Agency: U.S. Nuclear Regulatory Commission
Advisory Committee On Nuclear Waste

Title: ACNW Working Group Meeting On Geophysical
Testing Methods for Characterization of a
HLW Repository Site In Tuff

DATE: Monday, April 22, 1991

Figure 3.2-1. Matrix correlating categories of geophysical methods, with SCP studies wherein geophysical data will be collected and used.

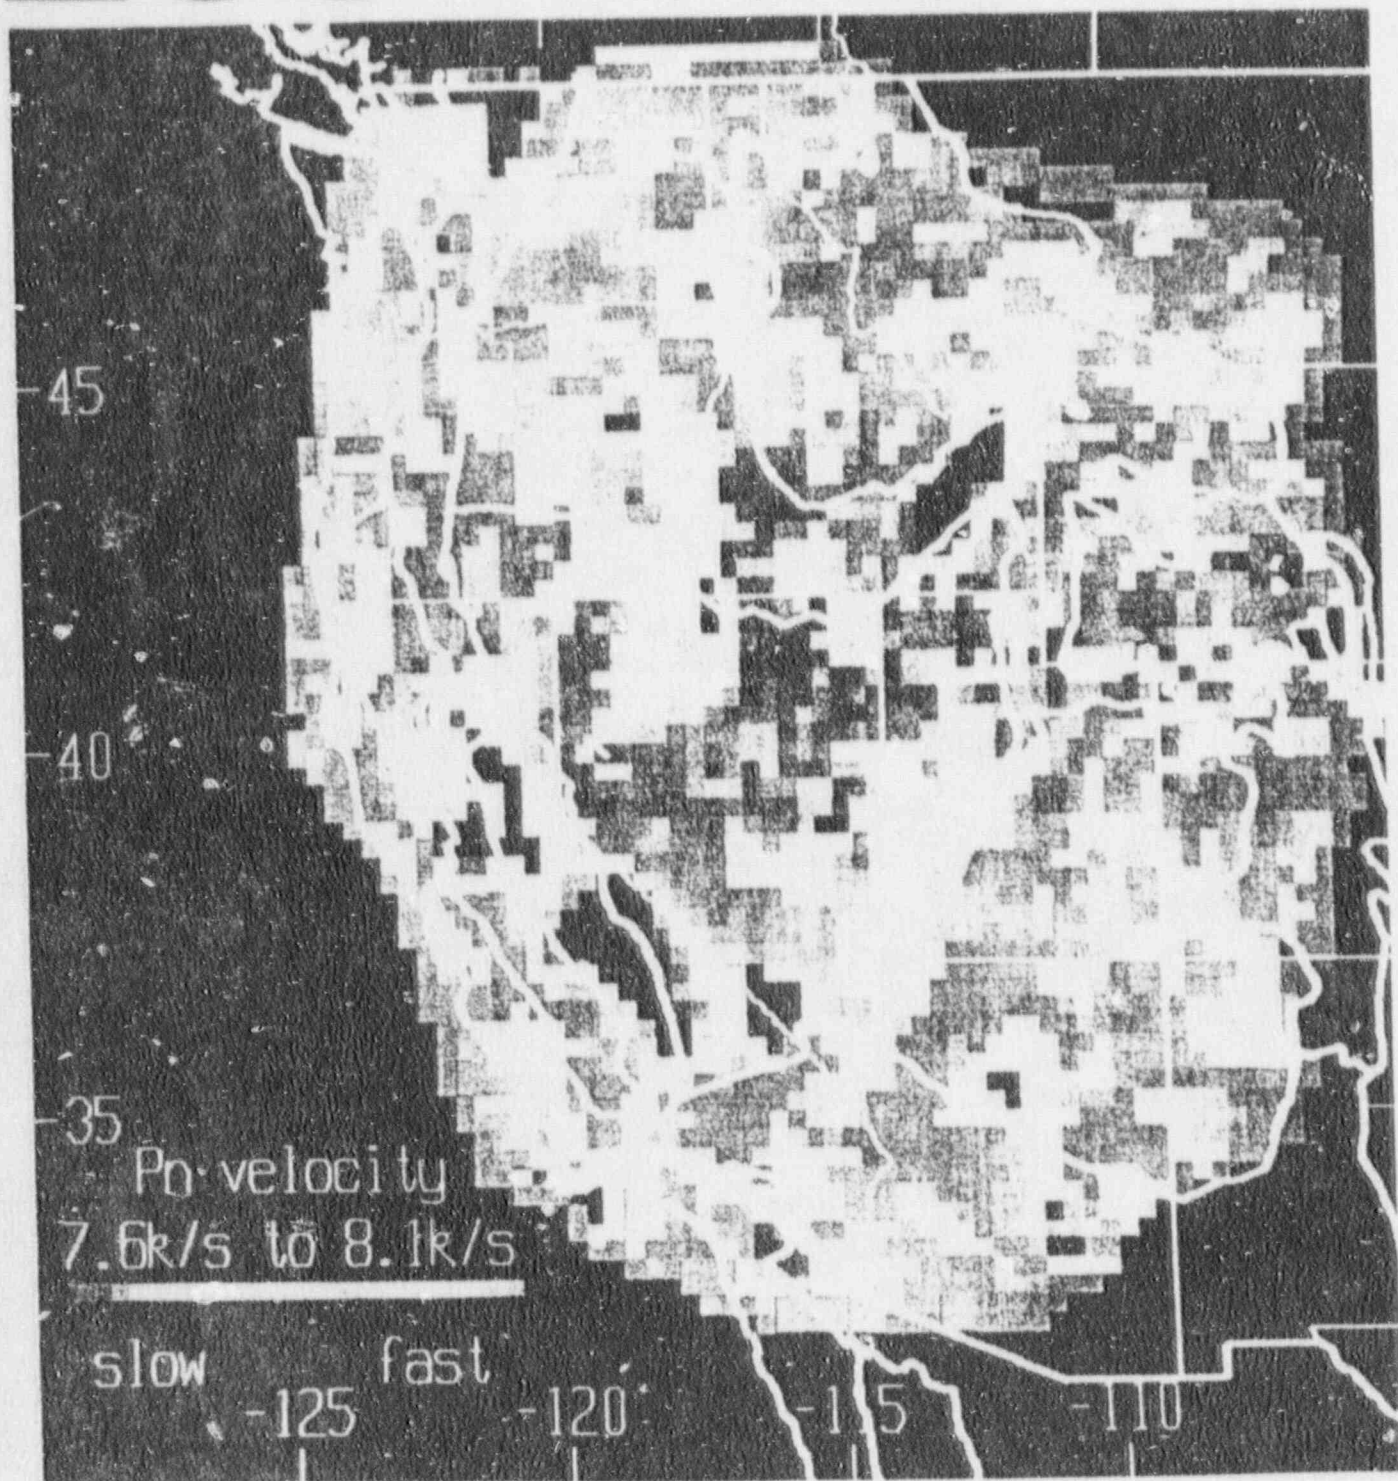
7 I had a lot of problems in trying to understand
8 and make something out of this table. So what I did is I
9 modified it slightly --

17 And I'd like to make three points on this
18 particular table, which gets to Walter Moody's comment about
19 integrated program, and a uniform program.

4 See, you took off all the small letters that show
5 how things are applied. We definitely are collecting data
6 for the volcanism study plan, it's just not collected in
7 that study plan.

16 MR. FRIDRICH: That's just not true. You just
17 took off all the small letters which show all of the data
18 that's collected for natural resources. It's just not
19 collected within that study plan as defined.

16 MR. FRIDRICH: Again, Carl, that one place is
17 where the data is collected and it's applied all up and
18 down. The capital letters just show where the data is
19 collected. It's not collected in every study plan over and
20 over and over again. We just collect it in one place and
21 then we apply it all over.

Figure 2 Approximate location of proposed seismic reflection surveys at Yucca Mountain.

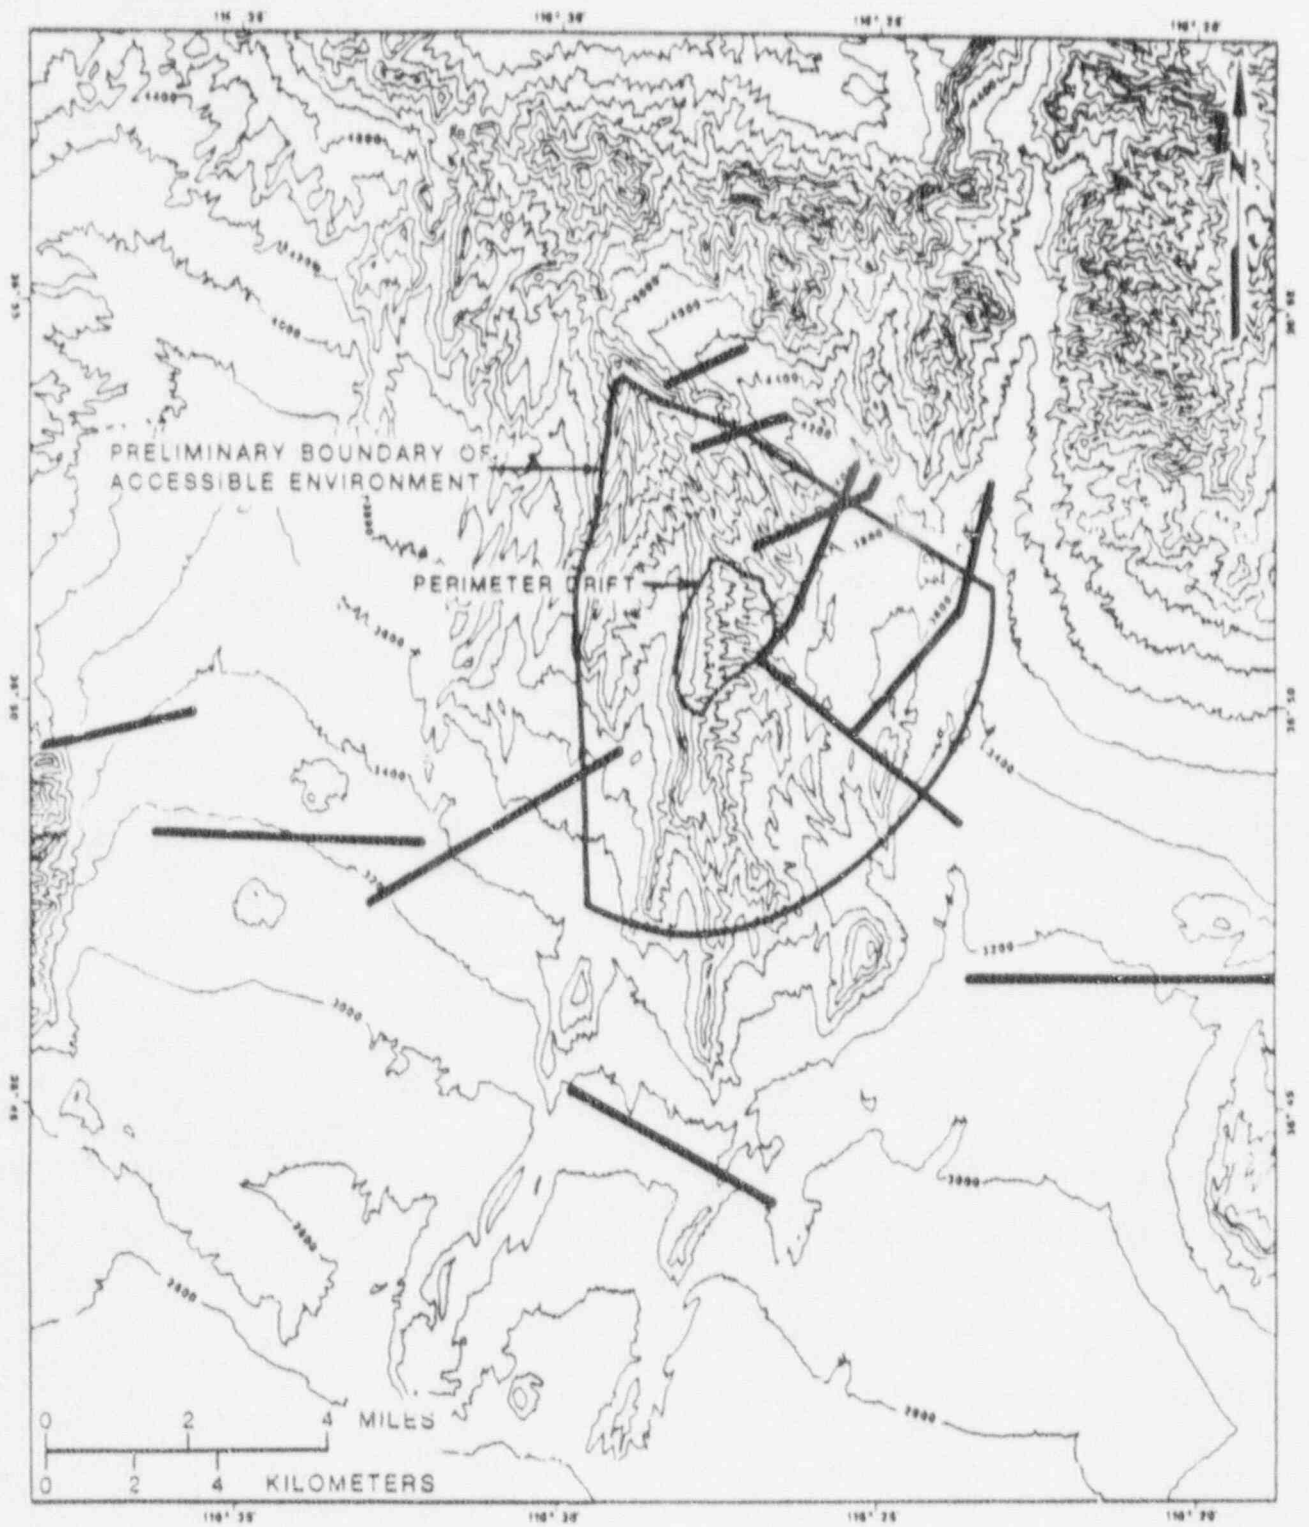
16 MR. IBRAHIM: Here also some of the location of
17 the reflection data which will be used for the investigation
18 of the Yucca Mountain site. As you can see, some of these
19 lines are very, very short, approximately two kilometers,
20 and what is the rationale between these lines and the
21 refraction line which I show you in the first picture.

Figure 3 Approximate locations of proposed gravity and magnetic surveys near proposed coreholes.

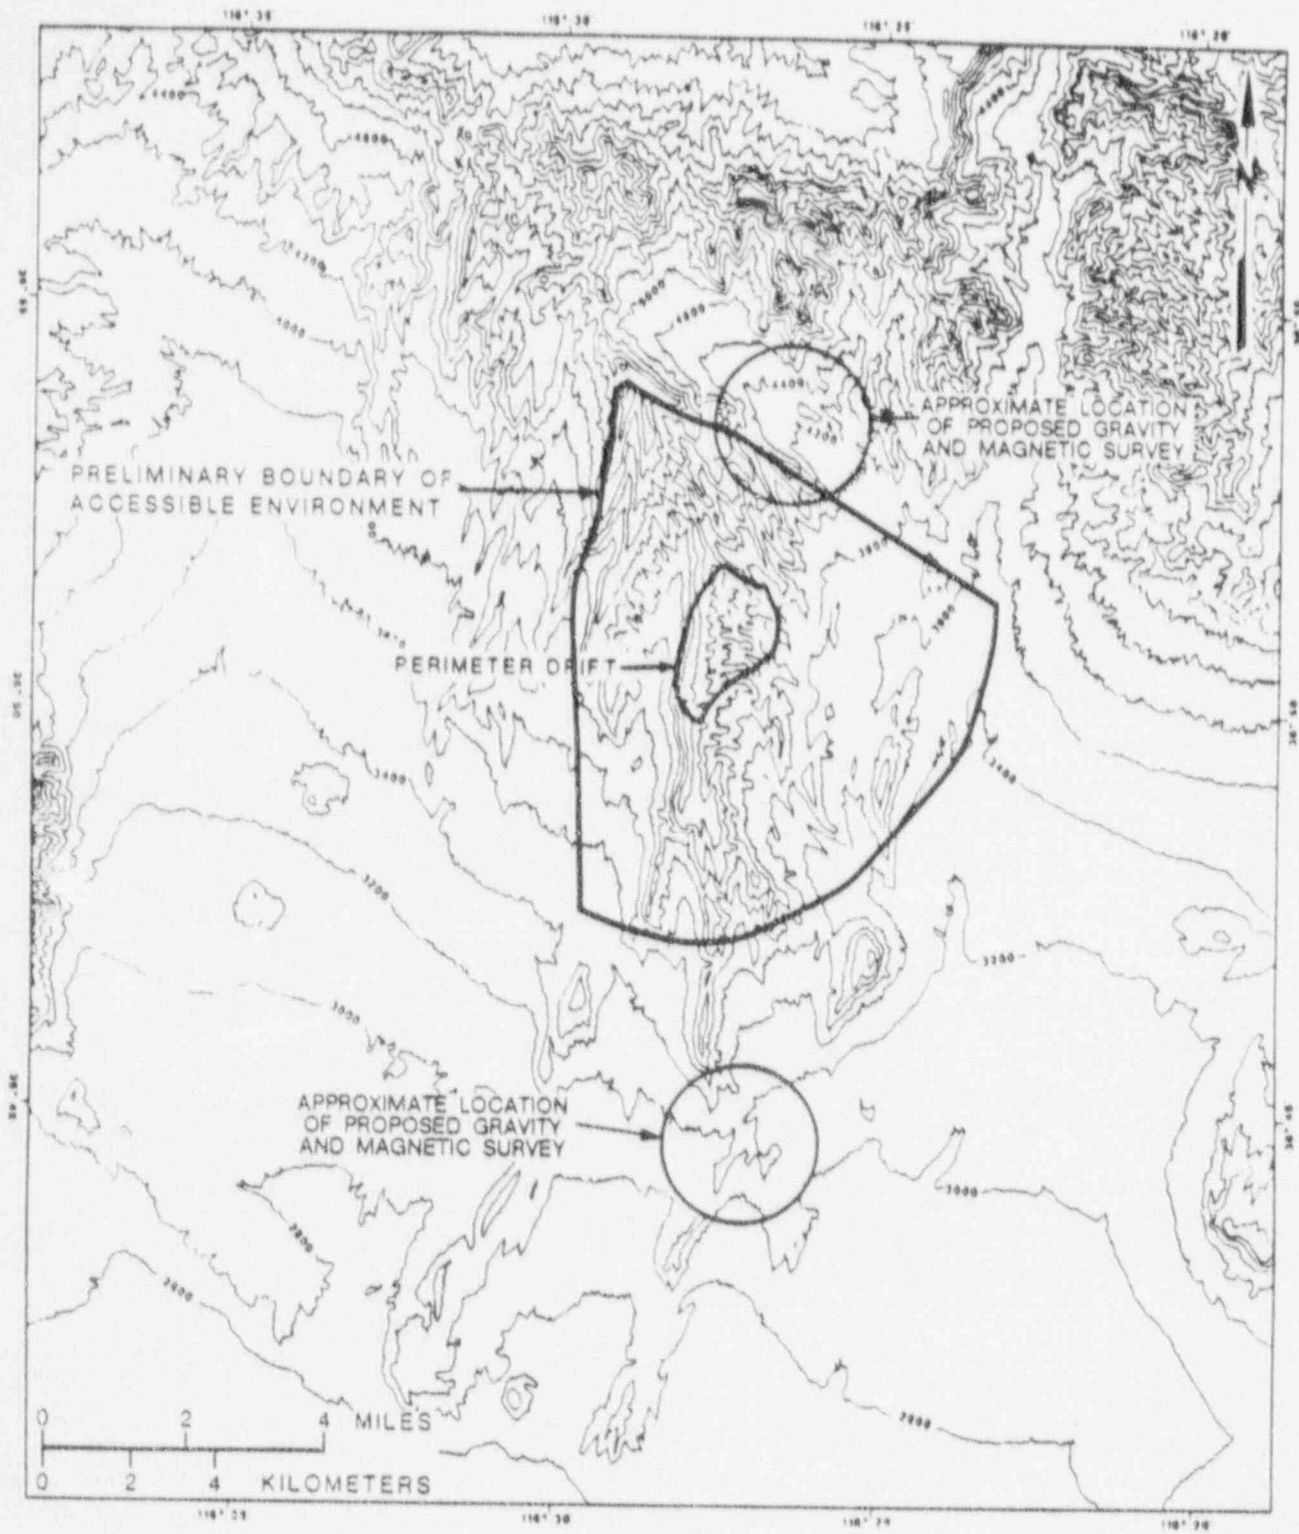
1 MR. IBRAHIM: Another figure shows the gravity and
2 magnetic data which will be acquired at Yucca Mountain.
3 Here we have two circles, one in the north and one in the
4 south, which identifies the location of the gravity and
5 magnetic survey which will be done by the Yucca Mountain
6 project.

13 MR. MOONEY: Well, I think the purpose of the
14 program to go back and get higher-resolution data right in
15 the area, your figure 3, is designed to do just that.

Figure 4 Locations of existing and proposed continuously cored holes at Yucca Mountain.

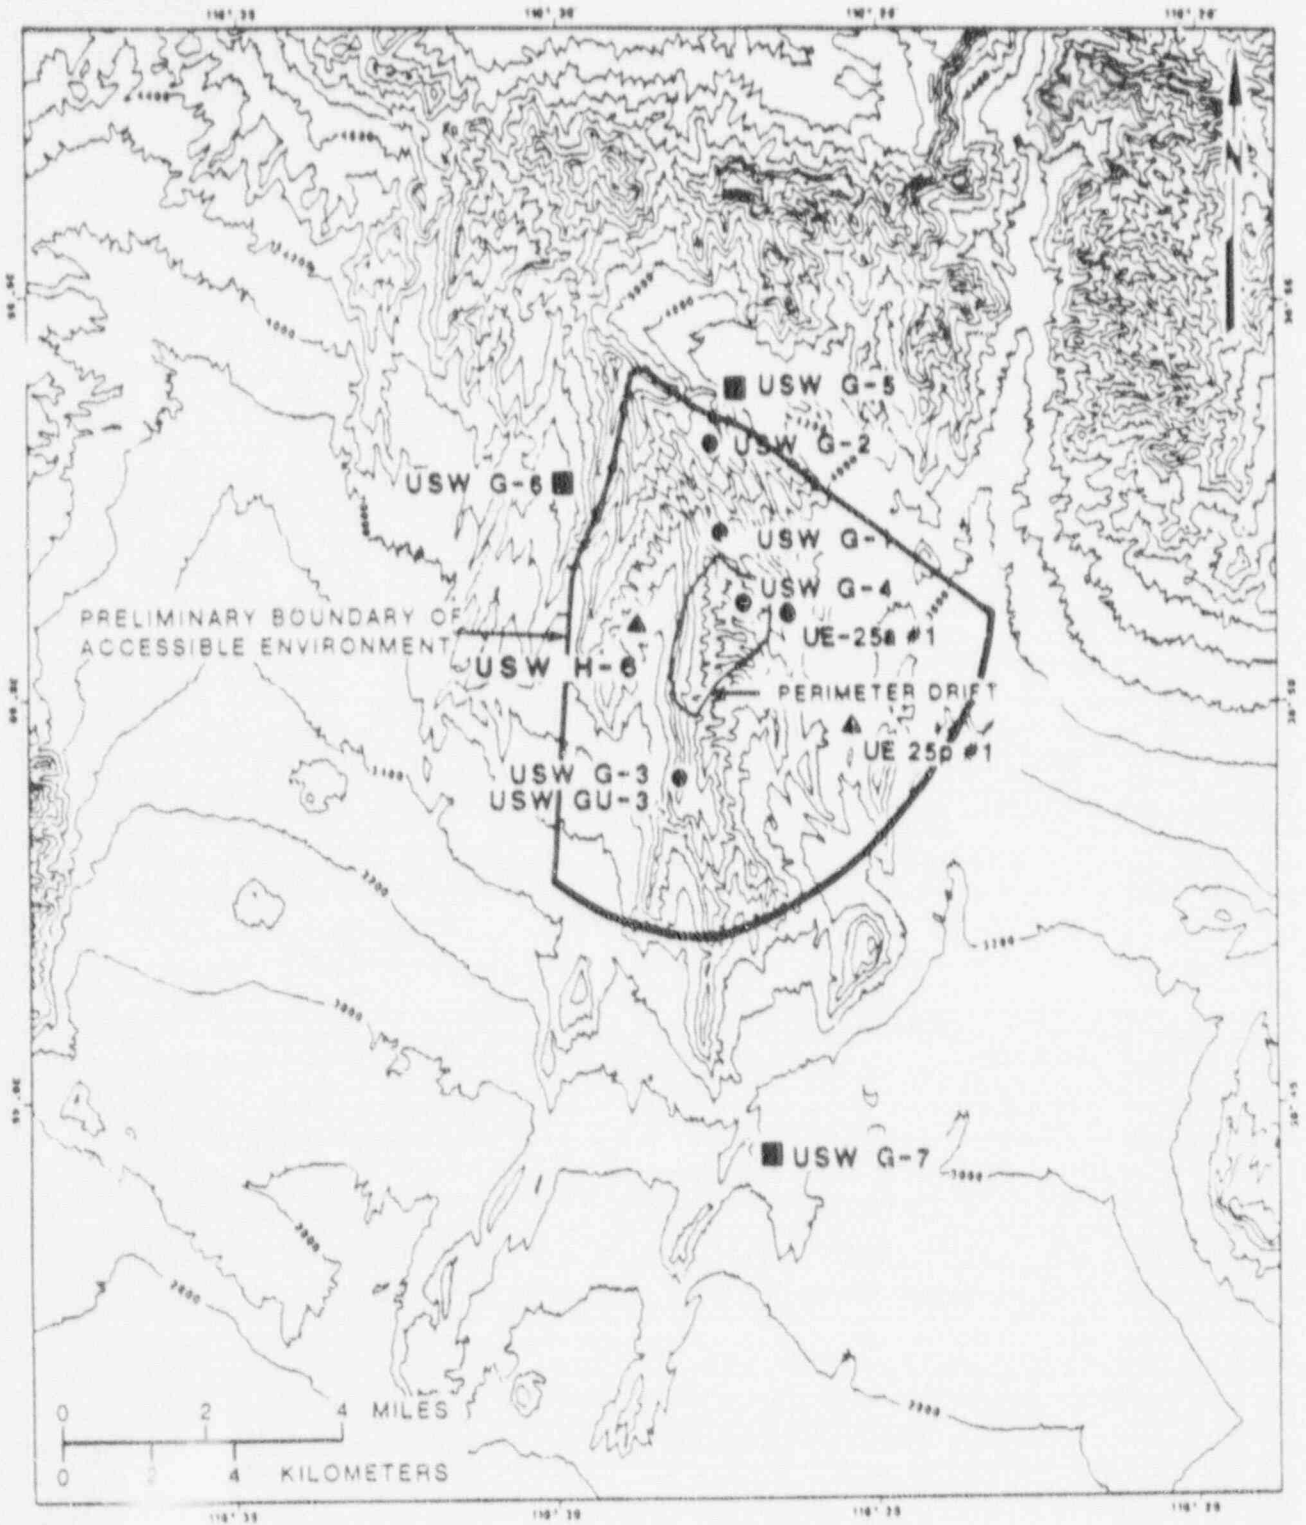
13 MR. IBRAHIM: Another figure shows you the
14 proposed continuously cored holes at Yucca Mountain, which
15 are represented by the square. We have three bore holes.

20 There wasn't any indication, because also we have
21 to consider what other purpose this bore hole will be used
22 for, so we can plan for the whole experiment.

Aeromag Survey - South YM

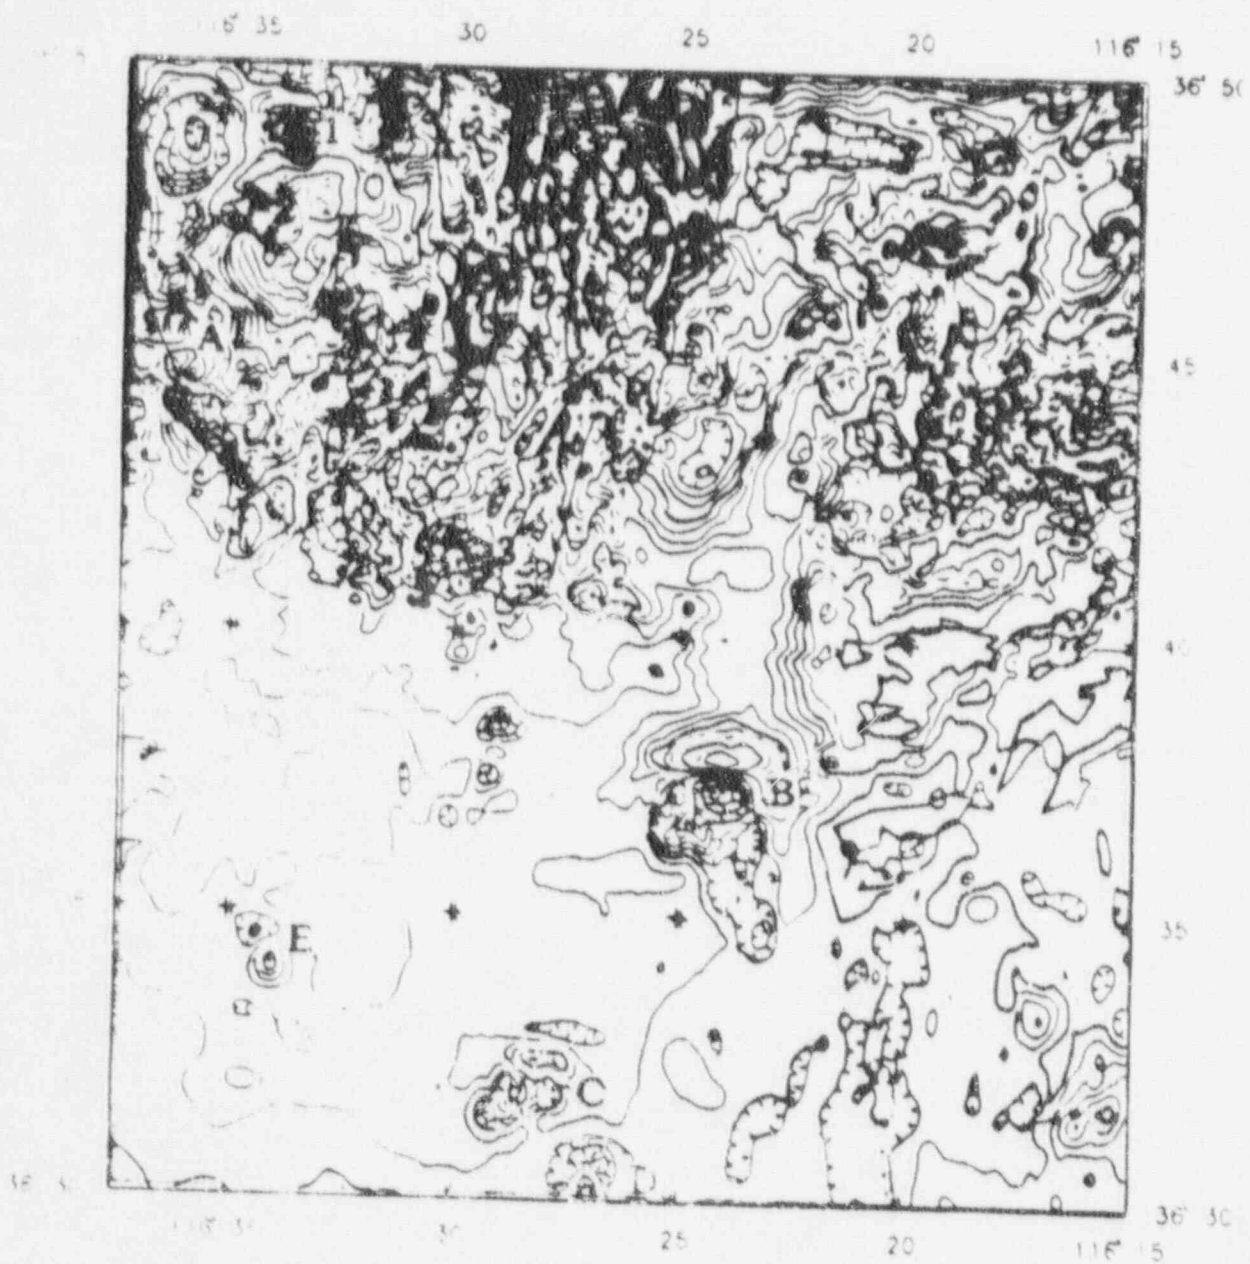
See comment 3
